Review of Air Quality Aspects of Gunns Ltd “Bell Bay Pulp Mill Draft Integrated Impact Statement, July 2006”

Prepared for
Resource Planning and Development Commission
Tasmania

Prepared by
M.F. Hibberd & P.C. Manins
CSIRO Marine & Atmospheric Research

Final Report
4 October 2006

Figure 1 Copy of TRS time series from Appendix D (Time Series Plots: Measurements at Gunns AQMS) of the GHD report “Proposed Pulp Mill Bell Bay Impact on Air Quality”. A horizontal line at 0 ppb has been added to aid in interpreting the data.

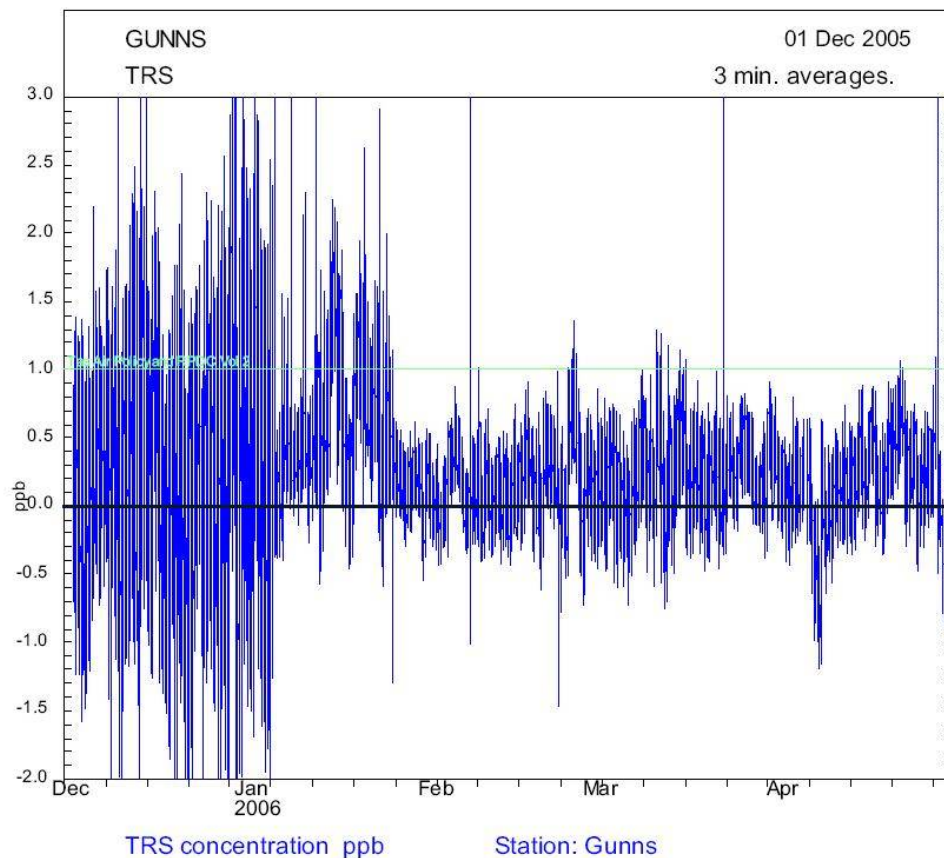
Notwithstanding the assumption of zero background concentrations, Table 9-3 shows that the TRS prediction on Mt George of 1.78 µg/m³ exceeds the RPDC criterion of 1.5 µg/m³. Figure 9.13 also shows a region near the plant where TRS exceeds the RPDC criterion. The GHD report presents an argument about the likely frequency of these exceedences given that the TRS emission rate used in the modelling is estimated to occur only sporadically for 88 hours per year. This gives return times for exceedences of the RPDC criteria of 54 years on Mt George

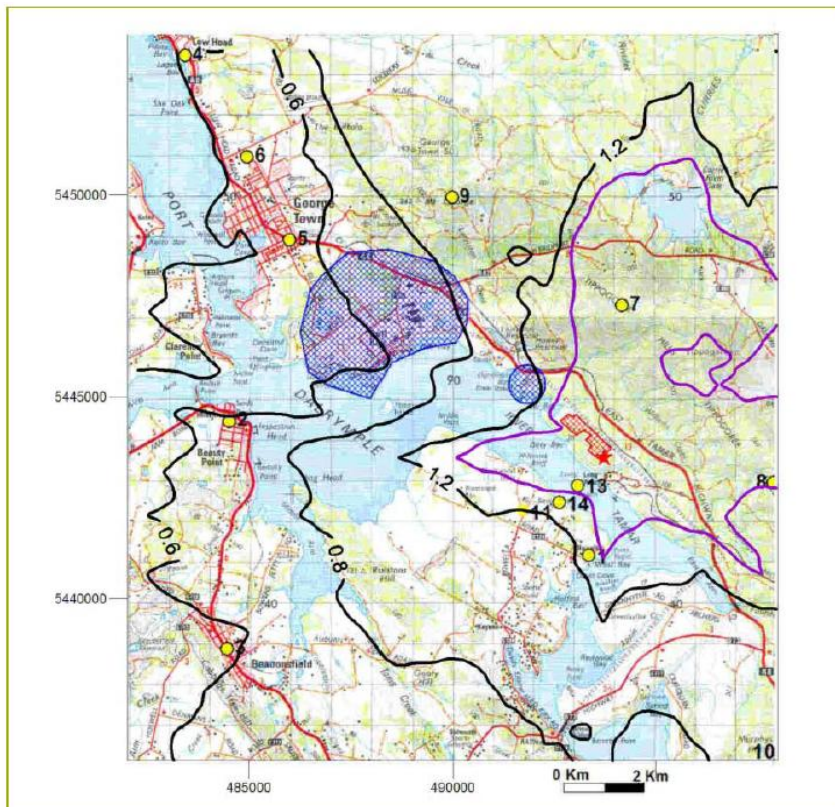
There are significant and unexplained differences between the some of the model results presented in the PAE and the GHD reports. Examples are shown in Figure 2 and Figure 3 of this review for TRS and ClO₂ and the significant features are described in the following dot points. The reasons for these differences need to be explained.

- Figure 2 for TRS shows that GHD predicts exceedences of the $1.5 \mu\text{g}/\text{m}^3$ criterion to the north-west around Mt George and 6 km to the east on Tippogoree Hills as well as in the immediate vicinity of the proposed mill. In contrast, the PAE modelling shows peak concentration about 3 km north-east of the proposed mill, but **the exceedence contours are not labelled** so it is not known what the peak concentration are. These concentration contours should be labelled. Also the region shown does not extend as far east as the GHD plot so there is no information on whether the GHD peak 6 km east of the mill also occurs in the PAE modelling. Furthermore, the high concentrations up to $5 \mu\text{g}/\text{m}^3$ close to the mill in the GHD plot are absent in the PAE plot. Given that both reports used the same mill emission rates and that the only significant changes were the year modelled and the source of the assimilated winds, the reviewers find it very unusual that the peak TRS concentrations near the mill from the low level or area sources would differ so much. The reasons for these differences need to be explained.

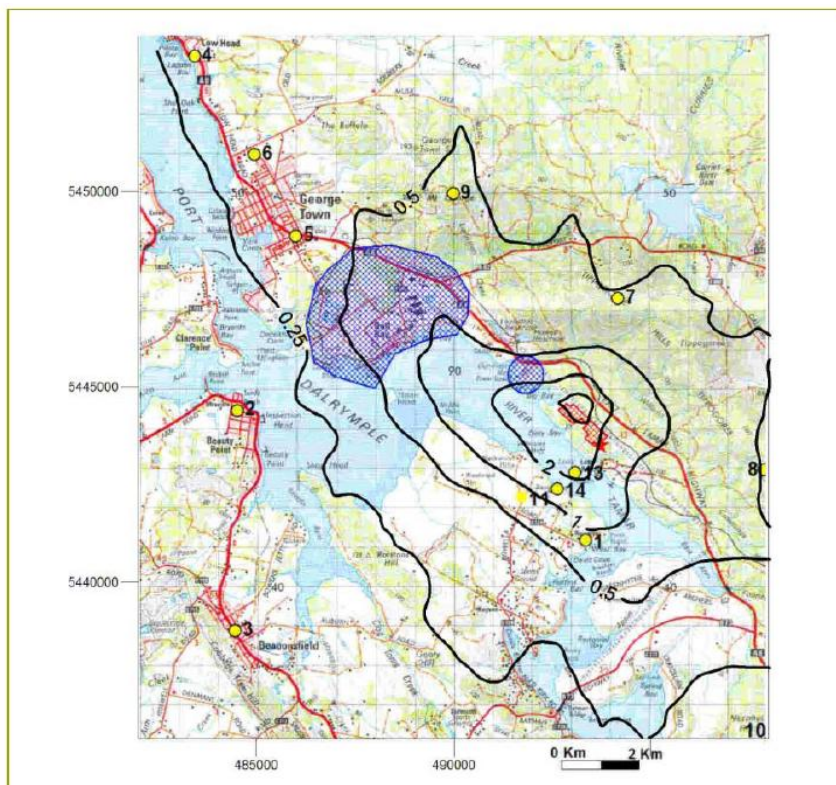
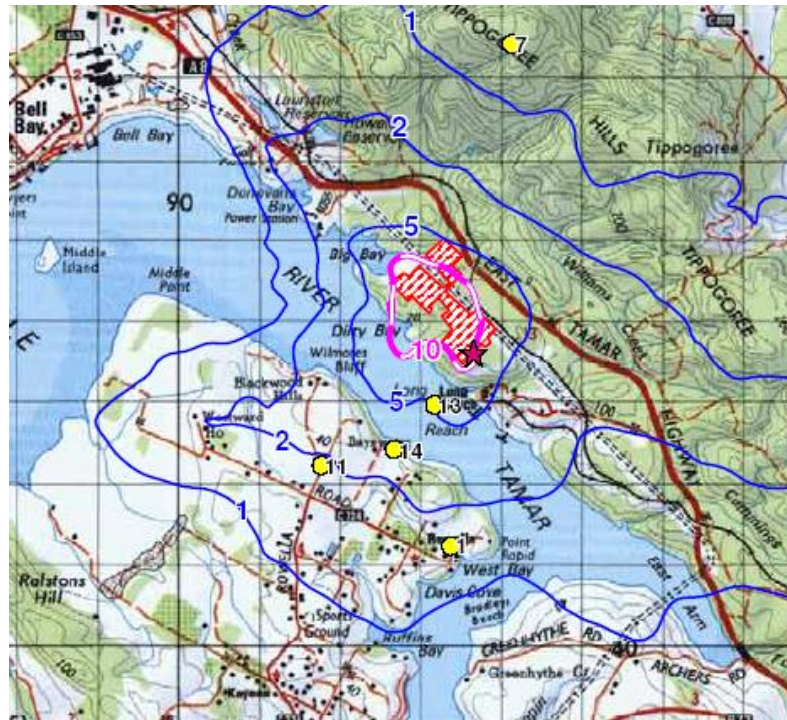
- Figure 3 for ClO_2 shows factor of two to three differences between the model results. The GHD report shows some exceedences of the $10 \mu\text{g}/\text{m}^3$ criterion, whereas the peak prediction in the PAE modelling is about $3 \mu\text{g}/\text{m}^3$. In the absence of any discussion about these differences, the reviewers have little confidence in the reliability of either set of predictions.

Figure 4 Comparison of wind roses for the Comalco AWS at Bell Bay and the Gunns AQMS near Rowella. Copied from Figures 2-5 and 2-7 on pages 2-6 and 2-8 of Volume 2, Part 2 of the Draft IIS.

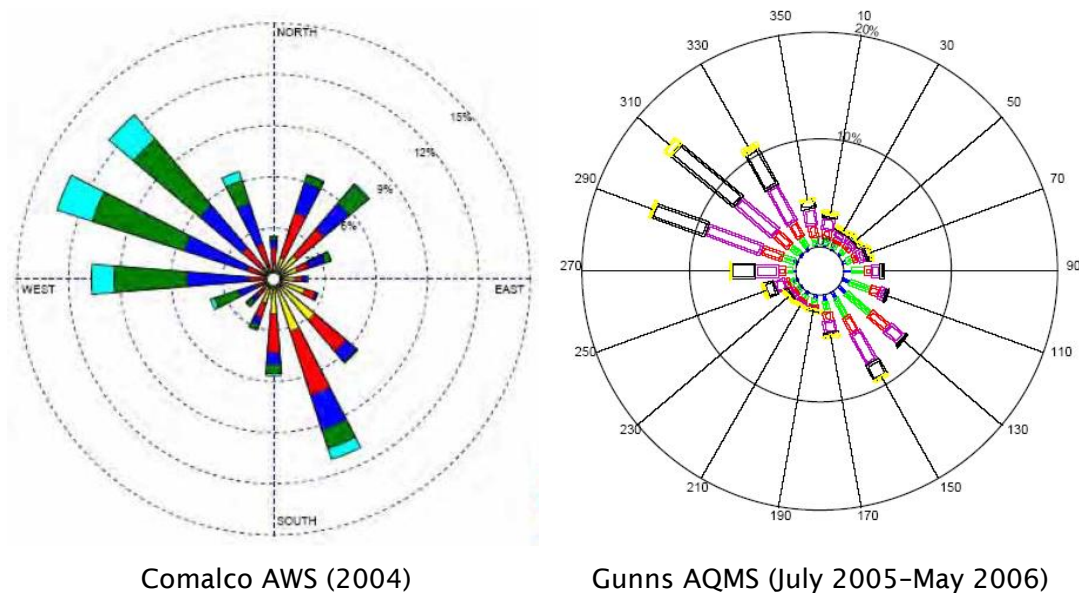
Section 2.4.2 compares the wind roses from the Comalco AWS (referred to as Bell Bay) for 2004 with those from the Gunns AQMS for July 2005–May 2006 and notes that “*the same dominant wind trends are observed for this site [Gunns AQMS], with fewer winds from the north-east*”. The wind roses are shown in Figure 4 of this review. The comparison shows that there are also far fewer westerlies and southerlies at the Gunns AQMS site. Because the data from each site are from different years, the differences may be due in part to the normal year-to-year variation in wind patterns, but the reviewers consider that the main differences arise

because of the different siting of the two stations, i.e. differences in local topography. The wind rose for the Gunns AQMS shows a stronger alignment of the winds along the NW-SE axis of the river at the proposed mill site and is thus considered to more representative of winds at the proposed mill.

Use of representative winds is important because the modelled winds at the proposed mill site are strongly influenced by the assimilated winds. The proposed mill site is approximately 5 km south-east of the Comalco AWS and 2½ km north-east of the Gunns AQMS. It is possible that these differences contributed to the differences between the predicted patterns of ground-level concentrations in the GHD and PAE reports.

Figure 5 Illustrative sketches showing the relative heights of the proposed pulp mill buildings and the 130 m main stack. Copied from Page 4-224 of Volume 2, Part 4 of the Draft IIS.

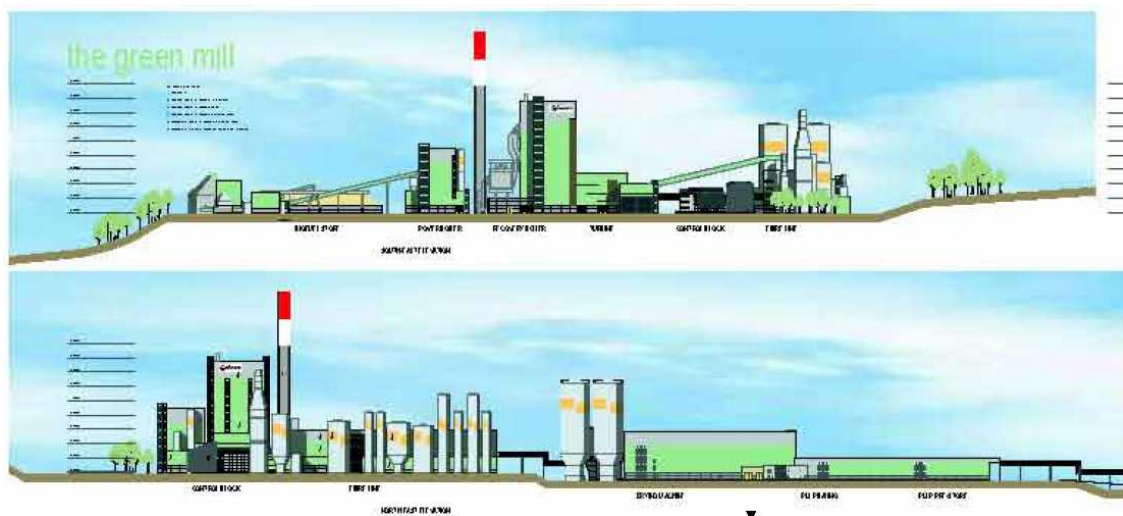
The main mill stack, which includes flues for the recovery boiler, lime kiln, non-condensable gas boiler, and power boiler, is proposed to be 130 m high. This is 1.5 times the height of the recovery boiler building (86 m) as indicated by the sketches in Figure 5. **This does not satisfy the principle in D.3.11** that *“It is sound engineering practice (USEPA 1985) for the exhaust stack to be at least 2.5 times higher than the recovery boiler building height and for the stacks from lime kiln, CNCG incinerator, CNCG emergency incinerator and power boiler to be taken to the same height as the recovery boiler stack. Site selection factors such as geographic location and air dispersion modelling will also influence the common stack height.”* **The arguments for selecting a lower stack height than the 2.5-times rule need to be presented.**
